From: Lee, Jae
Sent: Wednesday, July 27, 2016 4:08 PM
To: 'Miller, Brett' <bmillier2@wm.com>
Cc: Setnicar, Mary <setnicar.mary@epa.gov>; Blough, James <Blough.James@epa.gov>
Subject: Vickery draft RCRA permit Emission Control Plan

The U.S. Environmental Protection Agency is in the process of conducting its technical review to support issuance of a draft RCRA permit to Vickery. During the course of this review, EPA has found that there is a compliance issue concerning vapor emissions from a hazardous waste unit operated by Vickery. Specifically, Vickery operates a Filter Pressure (FP) unit to remove solids from the hazardous waste. The FP is located in a room enclosed by room walls, and the hazardous cakes from the FP are manually removed and dumped into a roll-off box. There is no vent or control device in the room. The room where the FP is located is considered as enclosure as defined in 40 CFR § 265.1081.

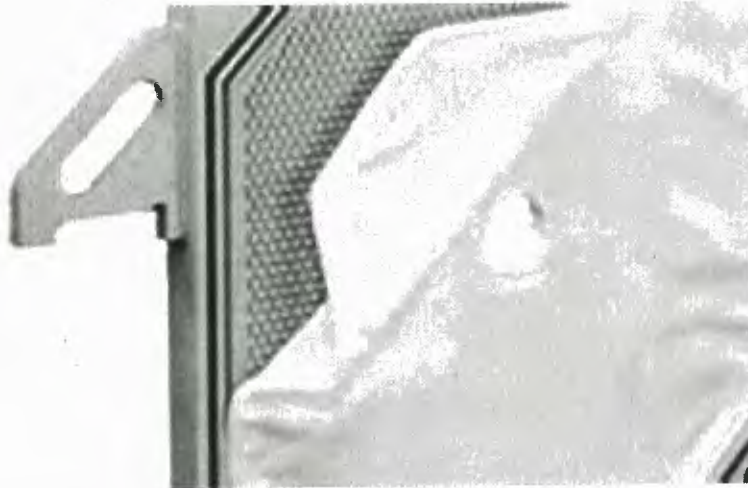
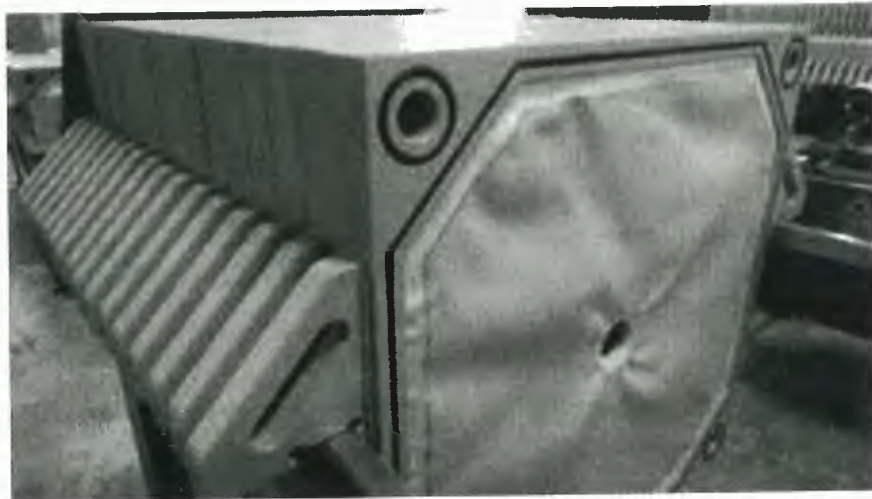
Question 2. We are also contacting the OEPA how the FP unit was classified as a Subpart X not as a container. In a meantime, can you email us a photo or a diagram of the FP unit, if possible?

Vickery Response to Question number 2.
Below are images of the filter press style we use. Images are courtesy of MW Watermark

The individual filtering plate is a two-part design: 1.) a Filter cloth and 2.) a filter plate that the filter cloth attaches to. The filter plate contains a perimeter gasket that prevent wastewater from exiting the housing when the filter plates are pressed together.

When multiple filtering plates are pressed together, they form a filter housing. Filter media (diatomaceous earth (DE)), is applied to the cloths. As waste water flows through the filter media, suspended solids are collected on the filter media.

Once a sufficient amount of suspended solids are collected on the filter media, a significant pressure drop occurs through the filter press. At this time the collected solids along with the filter media must be removed. To remove the solids and filter media, the filter press is opened and the individual plates are separated. If needed, the filter plates are removed from the filter press and transported to another location.
